Effective Return Loss (ERL): A New Parameter To Limit COM Variability

For Comment Resolution of r02-26, r02-55, and r02-56

IEEE P802.3bs Task Force

July 2017

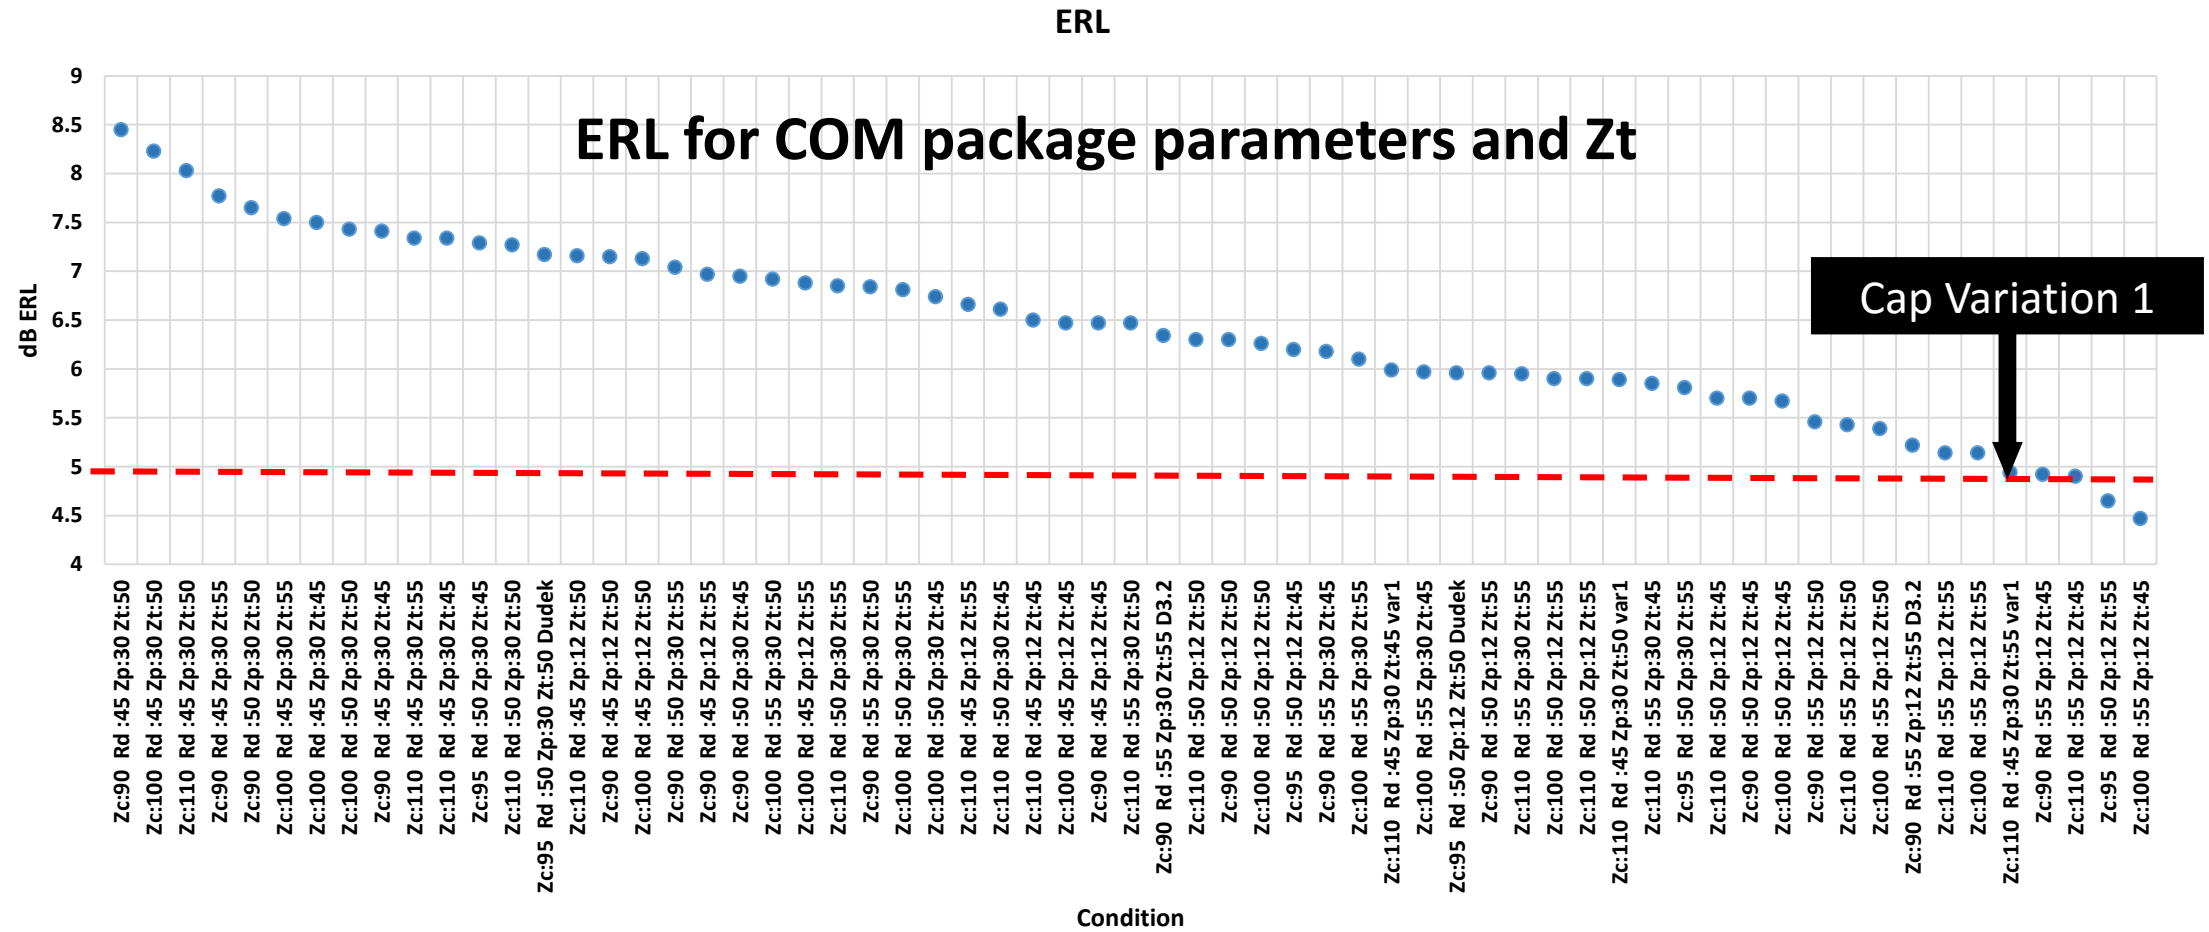
- ❑ Package criteria: adjust ERL so that “Cap Variation 1” is unfavorable
- ❑ Channel criteria: adjust so ERL channels with the most COM delta are unfavorable

Set Tx ERL > 5.5 dB (better than *dudek_062817*)

Set Rx ERL > 5.0 dB (better than *dudek_062817*)

120D.4 200GAUI-4 and 400GAUI-8 chip-to-chip channel characteristics

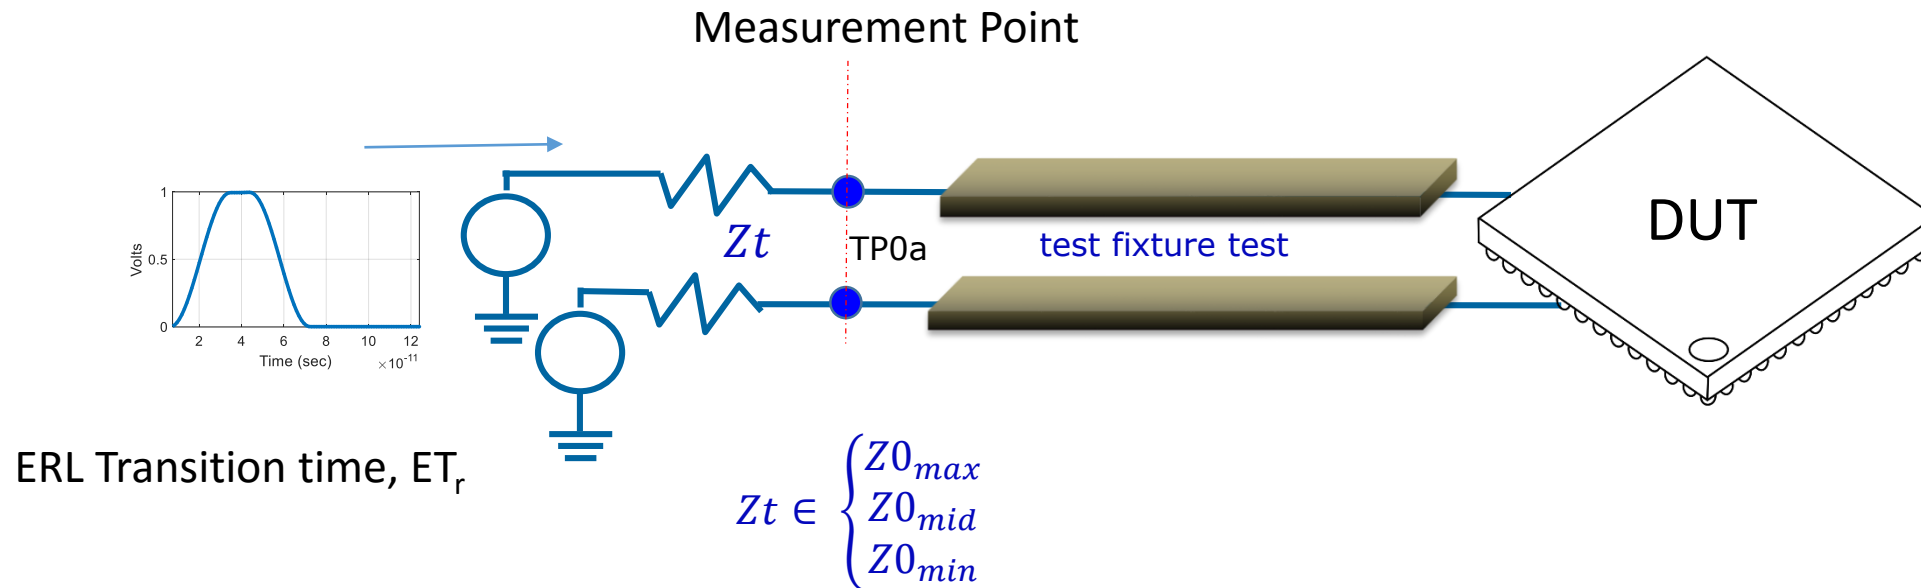
Suggestion 3: Add ERL to Channel Characteristics

□ ERL for the channel is greater than 5 dB.

- use a 18.9 ps (20%-80%) transition time and
- Use a 4th order Bessel-Thomsen Filter with the 3 dB point at $0.75 f_b$
- $Z_t \in \begin{cases} 55 \\ 50 \\ 45 \end{cases}$

The Channel Operating Margin (COM), computed using the procedure in 93A.1, where T_r is 13 ps, β is 2 for $H_r(f)$ in Equation (93A-19), and the parameters in Table 120D-8, shall be greater than or equal to 3 dB. This minimum value allocates margin for practical limitations on the receiver implementation as well as the allowed transmitter equalization coefficients.
